SUBDIVISION REVIEW SHEET**CASE NO.:** C8-2019-0146.1A**COMMISSION DATE:** December 6, 2022**SUBDIVISION NAME:** Thaxton Subdivision, Small Lot Subdivision, Phase One**ADDRESS:** E. Slaughter Lane & Thaxton Road (TCAD Parcel: 0339010369)**APPLICANT:** M/I Homes of Austin, LLC (Royce Rippey)**AGENT:** LJA Engineering (Russell Kotara, P.E)**ZONING:** Interim-Annexed 8/8/2022 (single family) **NEIGHBORHOOD PLAN:** n/a**AREA:** 56.21 acres (2448507.6 sf)**LOTS:** 152**COUNTY:** Travis**DISTRICT:** 2**WATERSHED:** Marble Creek**JURISDICTION:** Full Purpose**SIDEWALKS:** Sidewalks will be constructed along streets.**VARIANCE:** None**DEPARTMENT COMMENTS:**

CITY OF AUSTIN
SUBDIVISION APPLICATION – MASTER COMMENT REPORT

CASE NUMBER: C8-2019-0146.1A
 REVISION #: 00 UPDATE: U0
 CASE MANAGER: Cesar Zavala PHONE #: 512-974-3404

PROJECT NAME: Thaxton Subdivision, Phase One
 LOCATION: 8617-8924 THAXTON RD

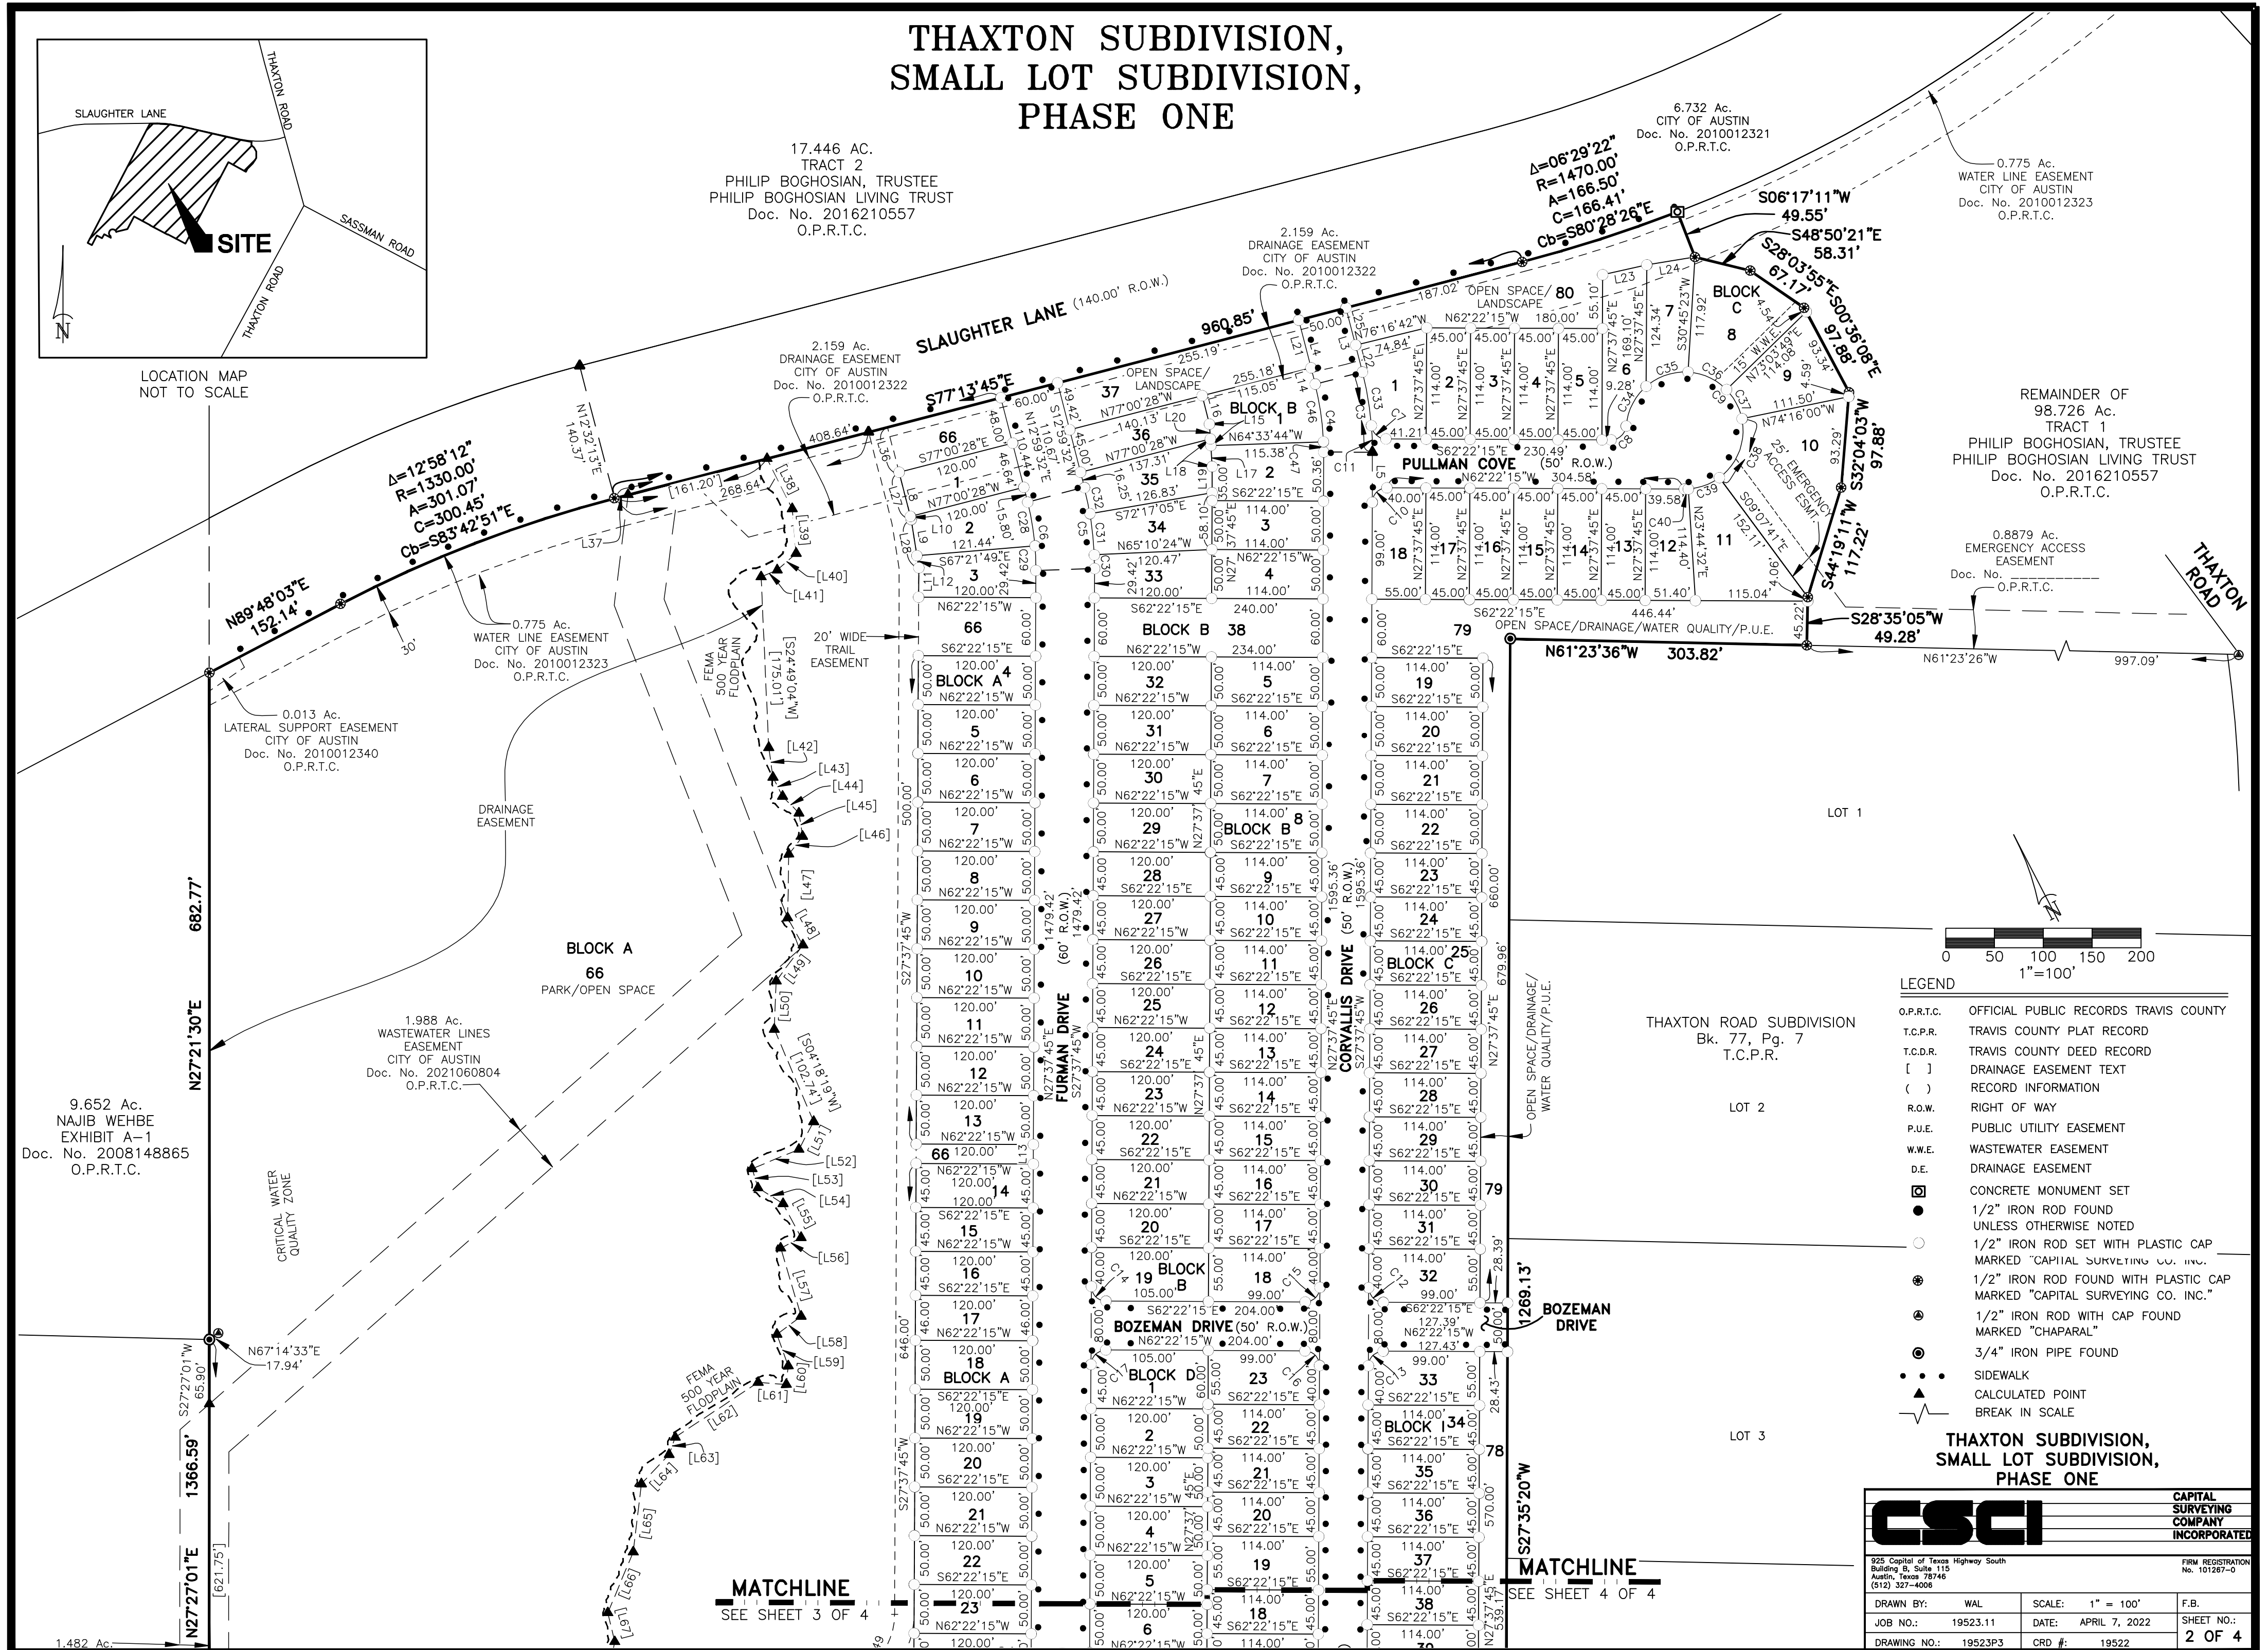
- ATD 3. Street right-of-way widths shall not be less than those specified in the TCM for Level 1 streets (TCM 3.4.0).
- ATD 4. In the approved Preliminary Plan (C8J-2019-0146) Block B 38 includes a sidewalk connection; include this in the Final Plat. Additionally, it is recommended to continue the sidewalk through Block 66 to connect to the trail easement. Edit General Note 13 to reflect this requirement.

SR 8. On sheet 2, annotate Lot 66 Block A and Lot 38 Block B accordingly. 25-1-83 or 30-1-113
